STAFF REPORT

NEW BEDFORD HISTORICAL COMMISSION MEETING

April 2, 2018

CASE #2018.09: CERTIFICATE OF APPROPRIATENESS
34 Union Street (Map 47, Lot 39)

Location of Proposed Café Seating Barrier

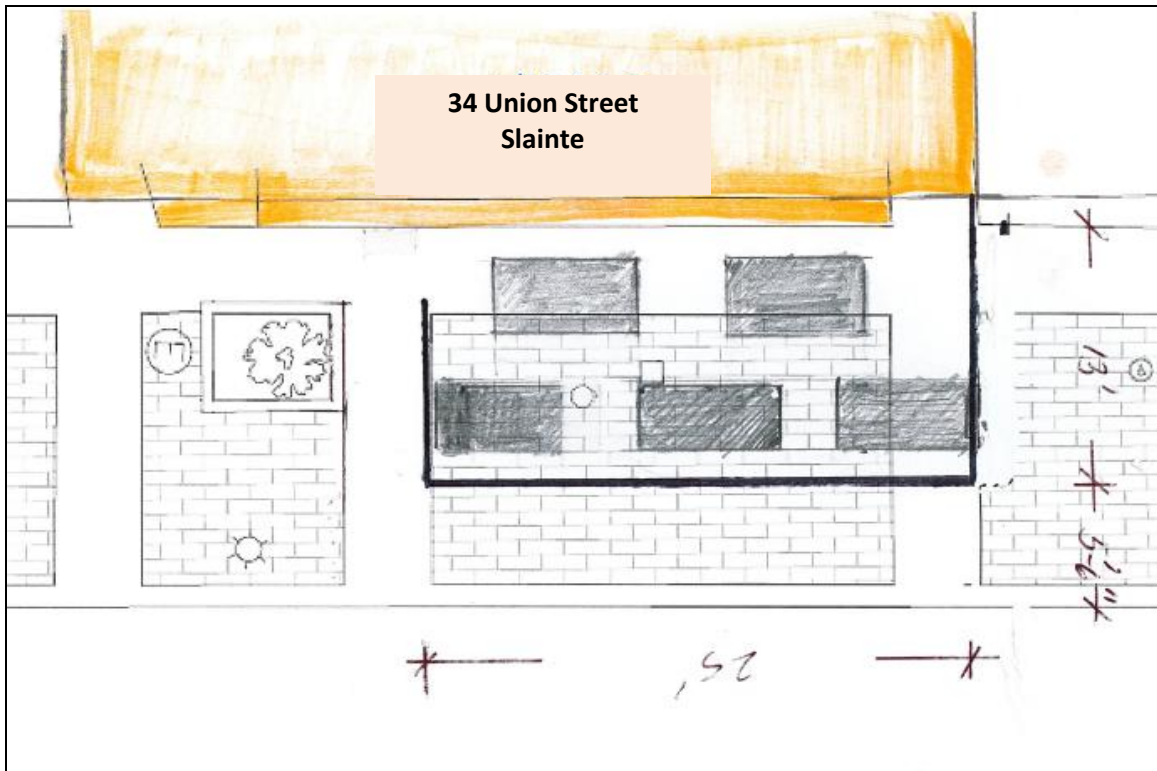
The 42" high wood barrier is proposed as a means to mitigate the noise and close proximity to vehicular traffic. The stained wood barrier with painted aluminum posts to support string lighting will seamlessly blend, and not detract from the aesthetic of the District nor obstruct the view of the Edward T. Caswell Building.

Relative to installation, staff recommends that all exposed concrete be dyed to match the brick pavers and that all post anchors be encased in wood. Staff further recommends that the Commission consider conditioning the approval upon the following: that the applicant secure any other permitting required for the barrier, that the applicant work with staff to ensure installation methods and materials adhere to the the design aesthetics of the District, and if substantal changes are required through additional permitting, the applicant may be required to seek a modification to the Certificate.
